**Proposal #18: 6414-00-78, WISC 2015 660
Village of Plover, Post Road
Green Drive to Springville Drive
Business 51
Portage County**

This is Addendum No. 01, which provides for the following:

ADDENDUM NO. 01
6414-00-78 & 6414-00-88
December 3, 2015

Addendum No. 01
ID 6414-00-78/88
Revised Sheet 228
December 3, 2015

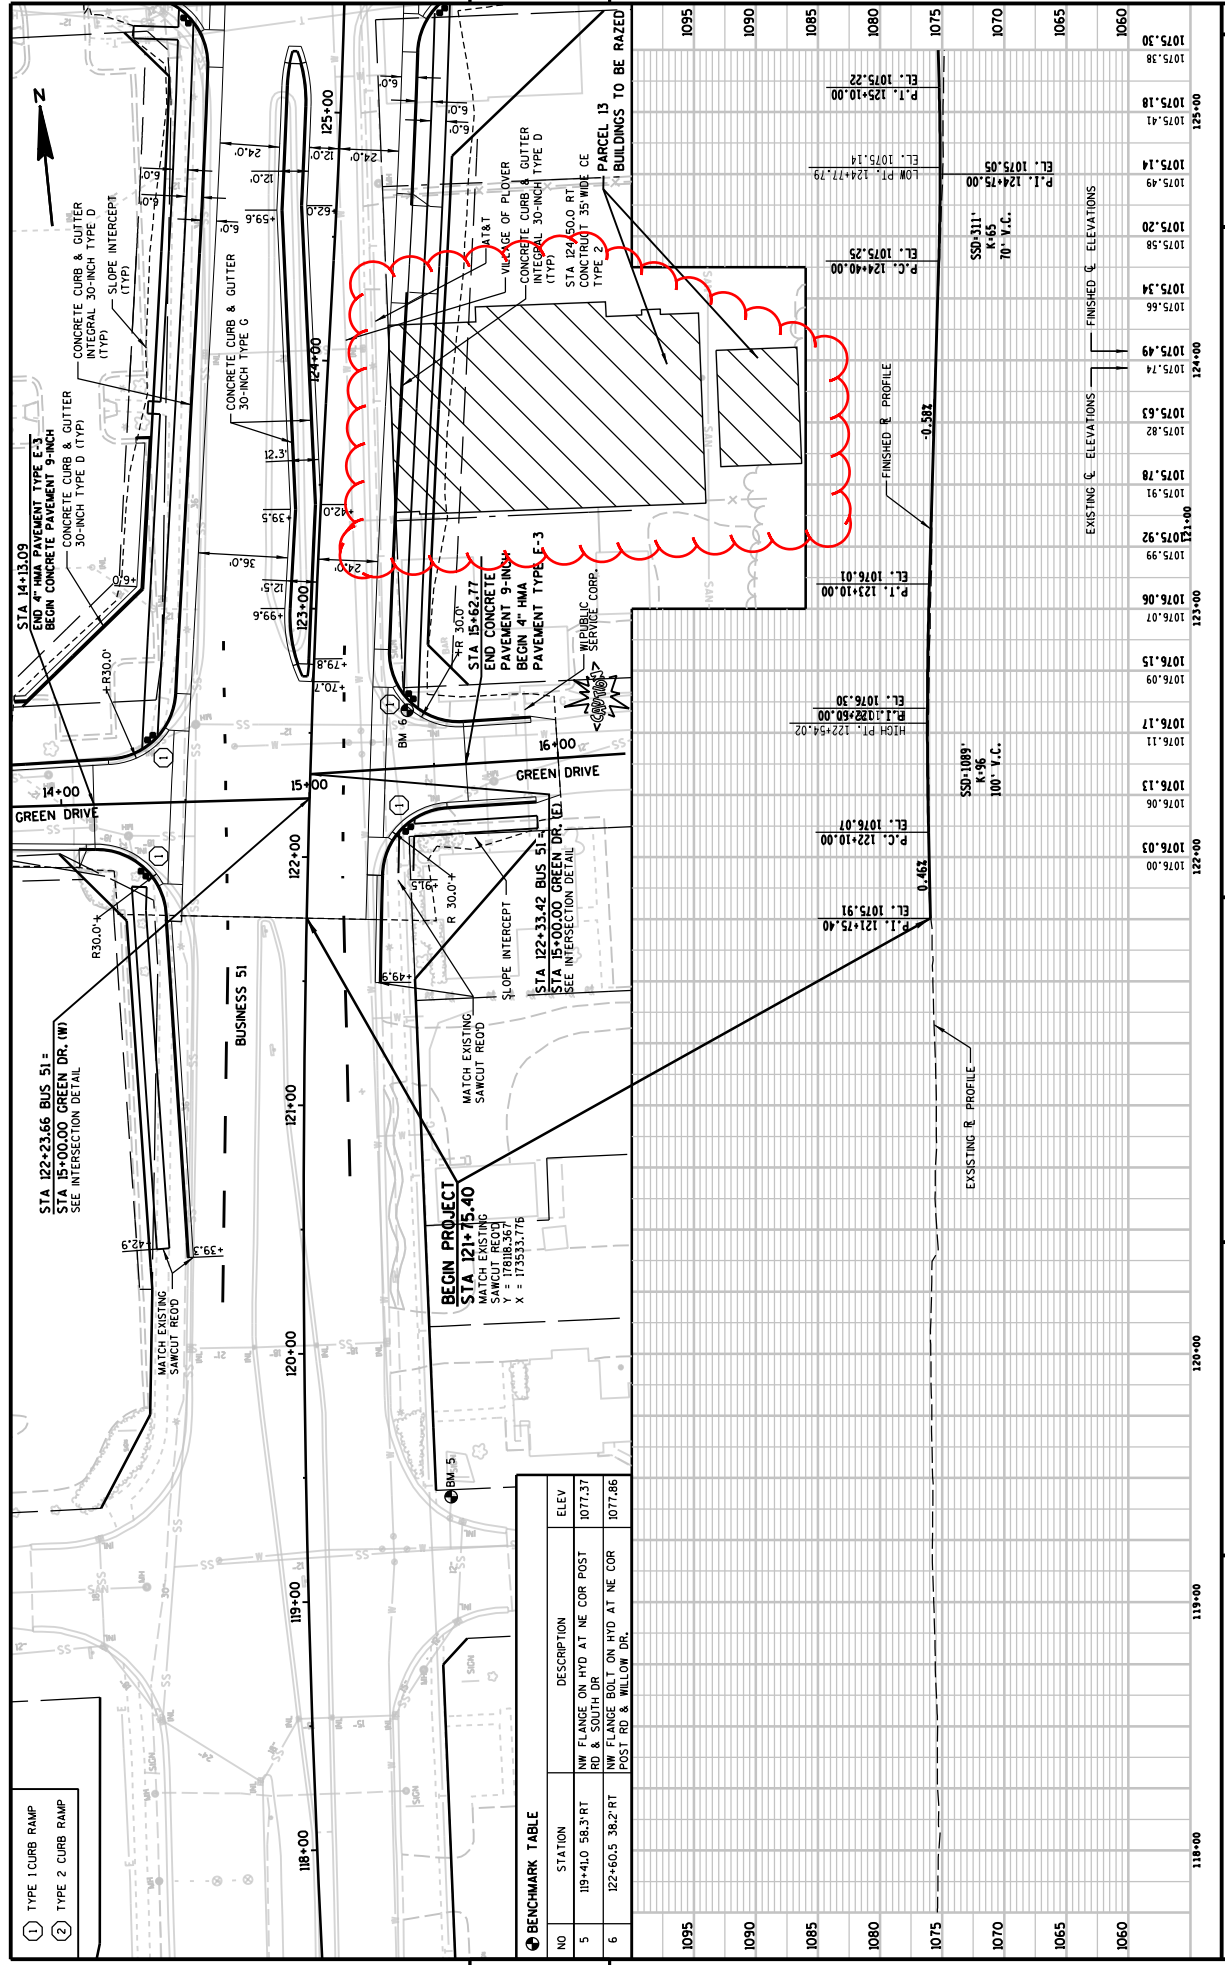
Revised Plan Sheets	
Plan Sheet	Plan Sheet Title (brief description of changes to sheet)
228	Miscellaneous Quantities (updates to quantities of Concrete Pavement)
266 & 267	Plan Profile Sheets (added note for location of buildings to be razed)

Revised Bid Item Quantities					
Bid Item	Item Description	Unit	Old Quantity	Revised Quantity	Proposal Total
415.0090	Concrete Pavement 9-Inch	SY	36,130	2,002	38,132
415.1090	Concrete Pavement HES 9-Inch	SY	9,587	531	10,118
